Access Compliance Report

Public Rights-of-Way

Intersection ID: 44690	Main Street: SMOOTH_PATH_DR	Cross Street: HARWOOD_HILLS_LN	Location: SW
ADA ID: 8CDA33E37C82	Ramp Type: PerpDiag	Initial Pass/Fail: Fail	Overall Compliance: No
Severity Score: 8.75			
Codes/Mitigation Info/Possible Solution		Field Measurements/Component Compliance

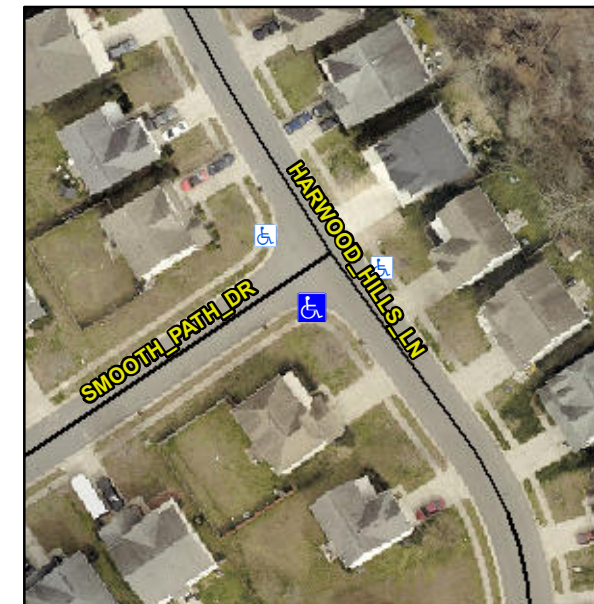
Not Found, R304.5.1

Compliance	Description	Data	Compliance	Description	Data
N/A	Ramp Length (in)	49.0	Yes	Ramp Slope (%)	5.0
No	Ramp Width (in)	47.0	Yes	Ramp XSlope (%)	1.5
N/A	Flare Type LT	N/A	N/A	Flare Type RT	N/A
N/A	Flare Slope LT (%)	N/A	N/A	Flare Slope RT (%)	N/A
N/A	Flare Traversable LT?	N/A	N/A	Flare Traversable RT?	N/A
N/A	Landing Length (in)	N/A	N/A	DWS Provided?	N/A
N/A	Landing Width (in)	N/A	N/A	DWS Contrast?	N/A
N/A	Landing Slope (%)	N/A	N/A	DWS Length (in)	N/A
N/A	Landing X Slope (%)	N/A	N/A	DWS Full Width?	N/A
N/A	Landing Curb? (Y/N)	N/A	N/A	DWS Offset (in)	N/A
N/A	Shared Landing?	N/A			
N/A	Gutter Ponding?	N/A	N/A	Gutter Slope (%)	N/A
N/A	Gutter Lip Ht (in)	N/A	N/A	Gutter X Slope (%)	N/A
N/A	Painted X Walk1?	No	N/A	Painted X Walk2?	No
	X Walk 1 Direction	To E		X Walk 2 Direction	To N
N/A	X Walk 1 Width (in)	N/A	N/A	X Walk 2 Width (in)	N/A
	X Walk 1 Slope (%)	3.0		X Walk 2 Slope (%)	2.4
	X Walk 1 X Slope (%)	3.1		X Walk 2 X Slope (%)	0.4

Remove & Replace Curb Ramp With Two New Directional Ramps or Equivalent.
